## Description of Permissive Change

This report is prepared for FCC class II permissive change. The difference compared with the Report No.: RF960308H04 design is as the following:

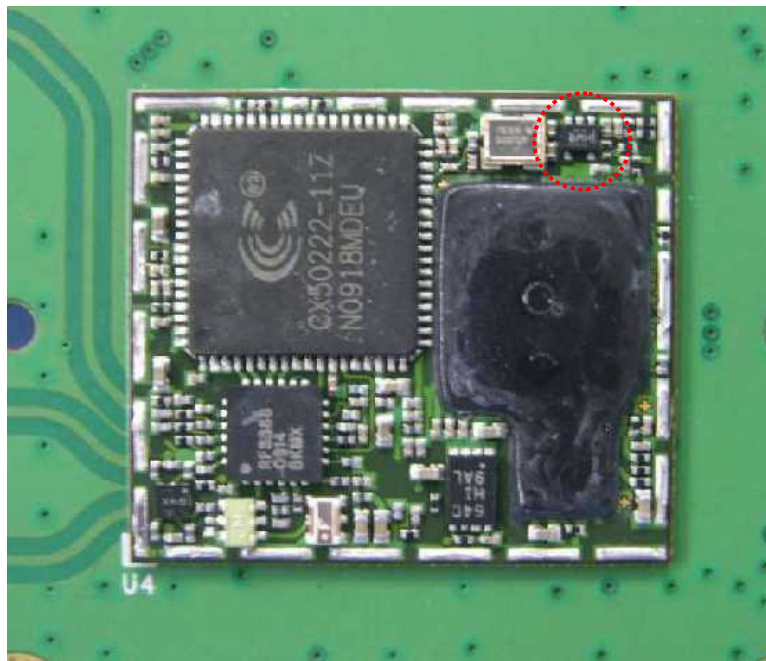
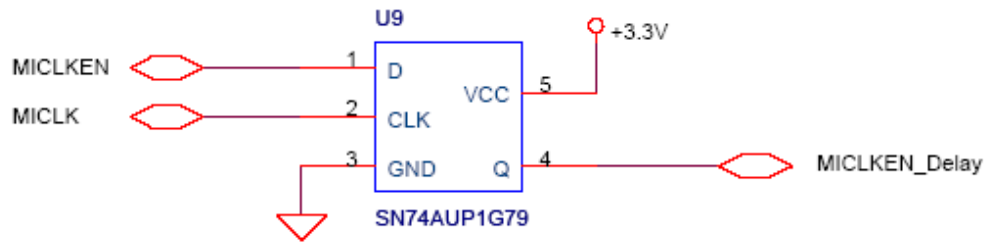
- Add Flip Flop to delay one signal to fix the memory self refresh.

- Shield Modification to improved Harmonic performance in 5GHz.
